FINAL DRAINAGE REPORT ADDENDUM

SUNSET VILLAGE FILING NO. 4

PCD File No. CDR-218

January 6, 2022

EX1

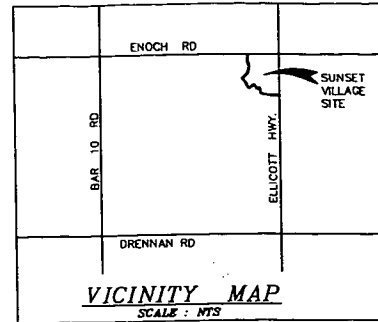
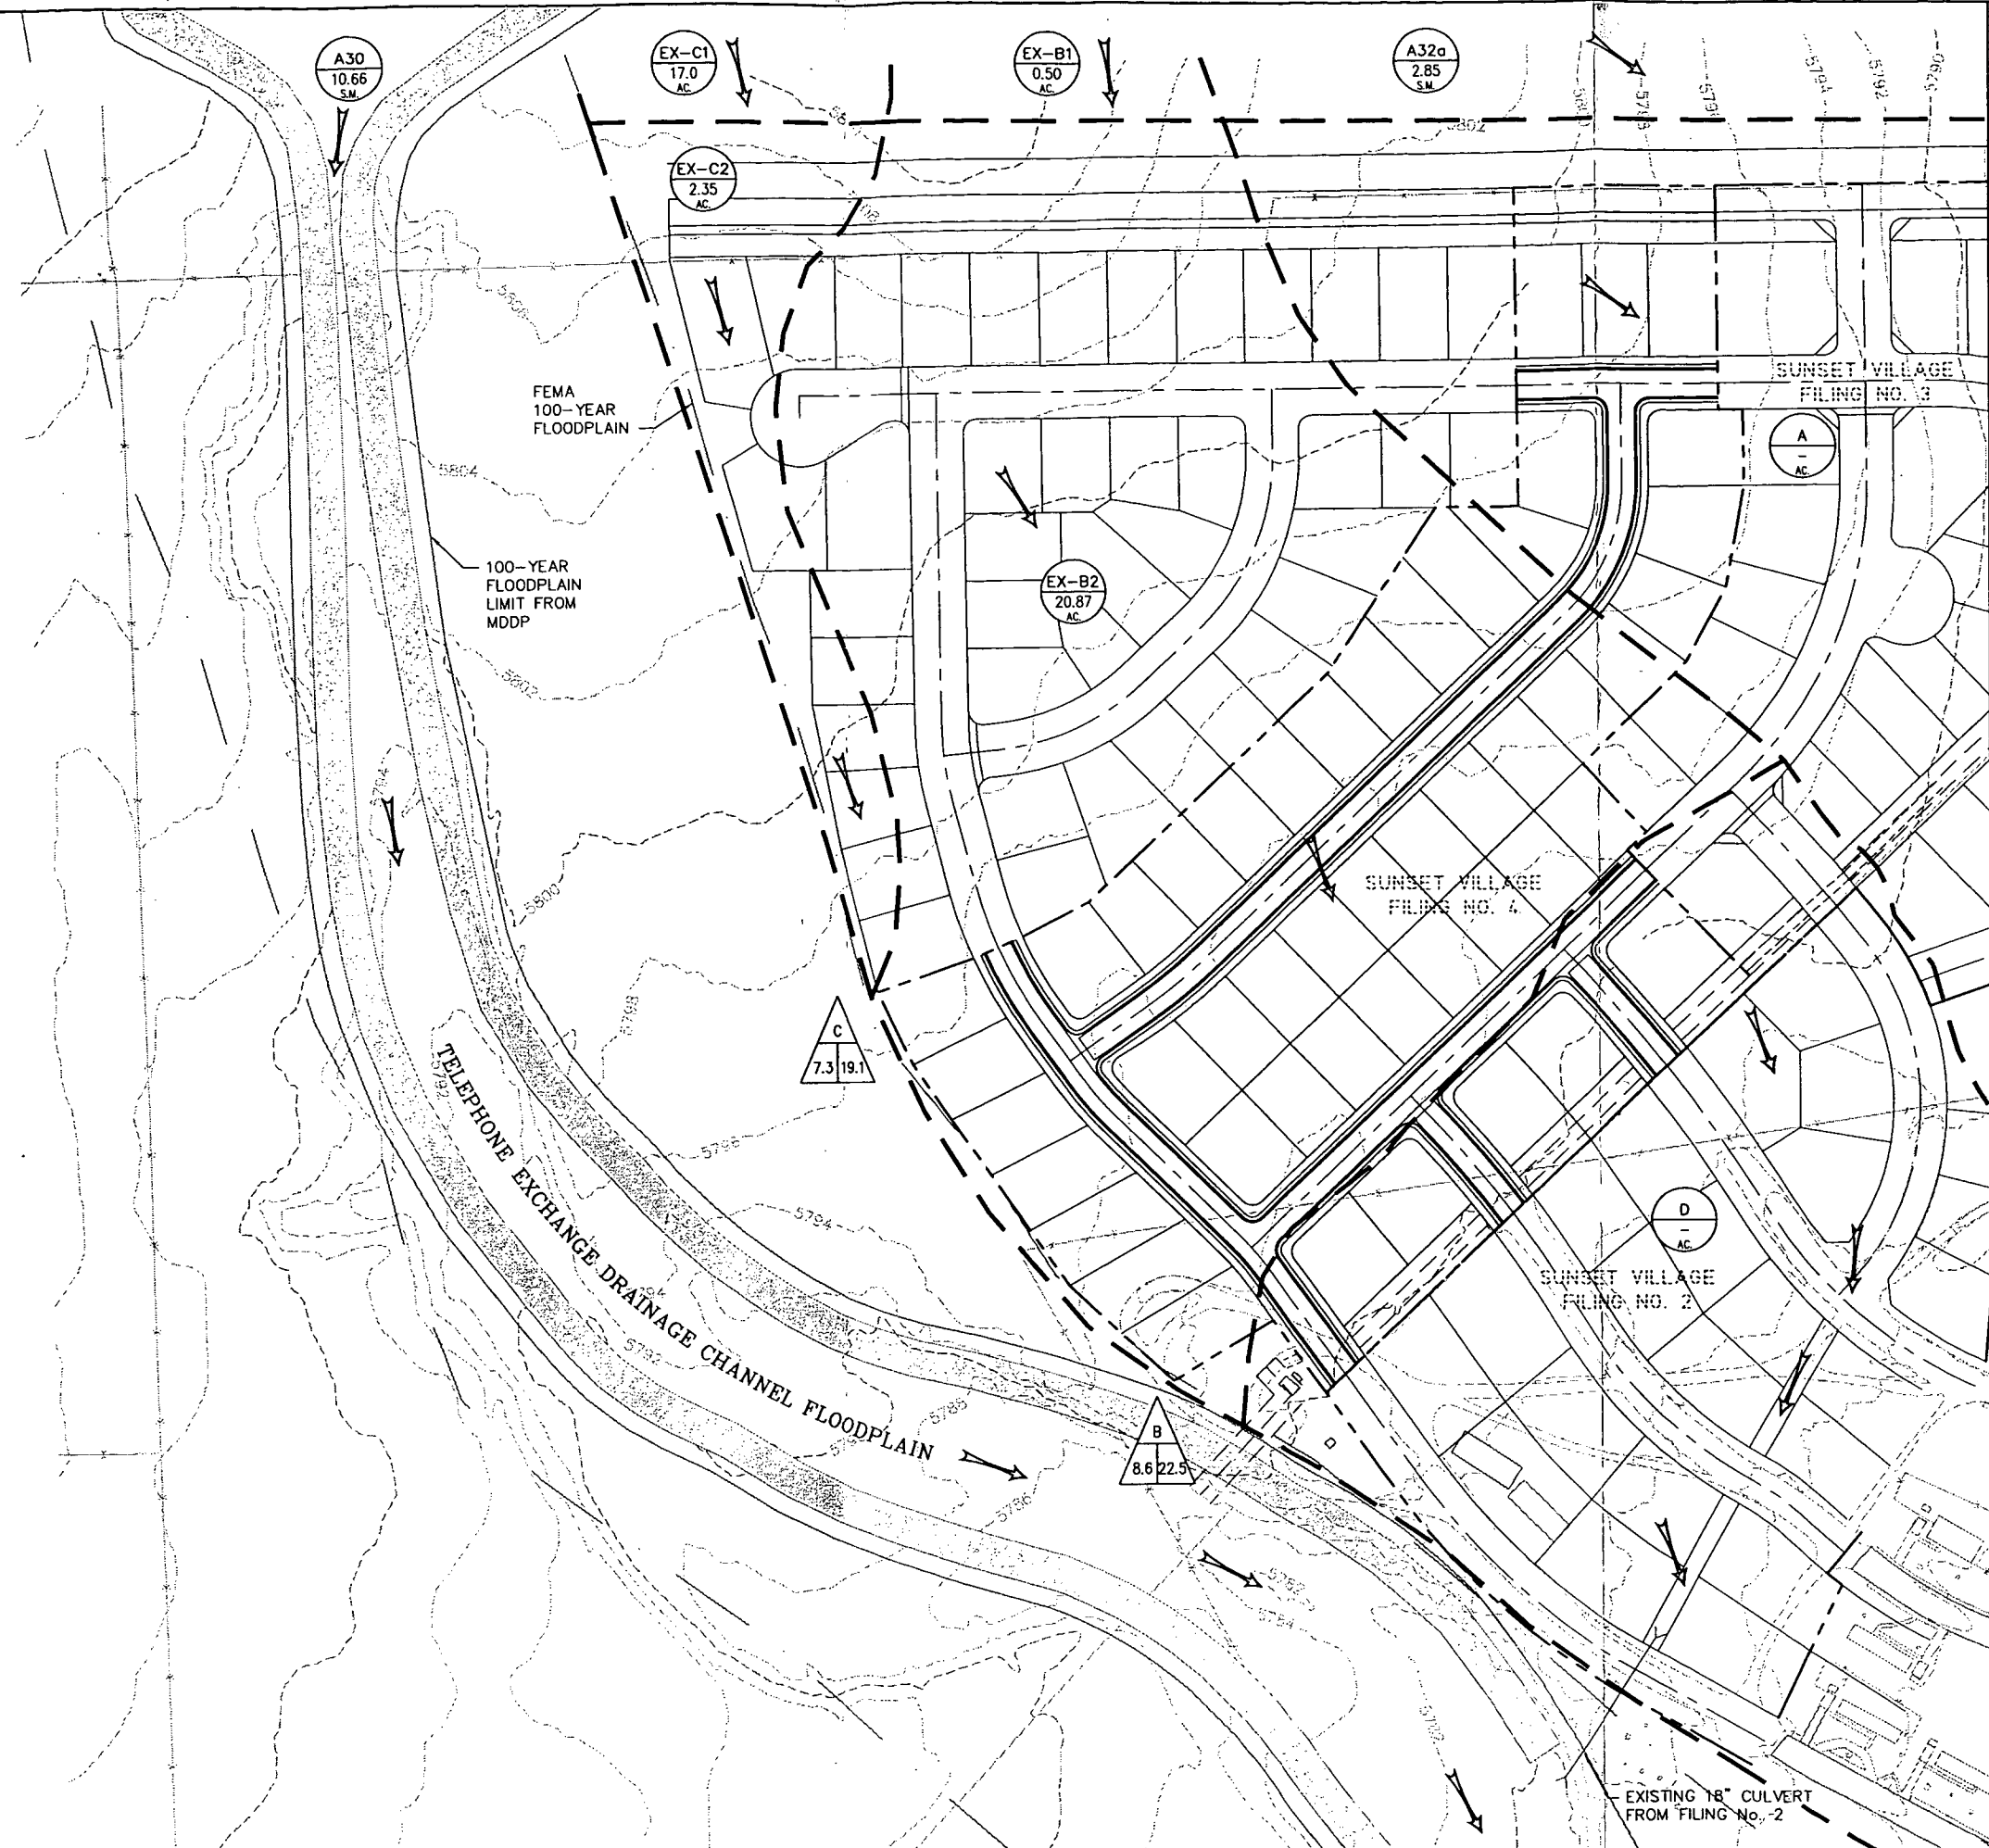
2. The applicant should label Design Points B3, B6, and B8 on the Drainage Plan.
3. The applicant should revise the Drainage Fees associated with this filing. Drainage fees for the Telephone Exchange Drainage Basin are \$5,267 per impervious acre. In addition, the applicant should account for the impervious area along the proposed streets. Comments are provided in the Drainage Report for clarification.

2. Design points B3, B6, and B8 have been labeled on the Drainage Plan.
3. The drainage fee calculation has been revised in accordance with previous comments.
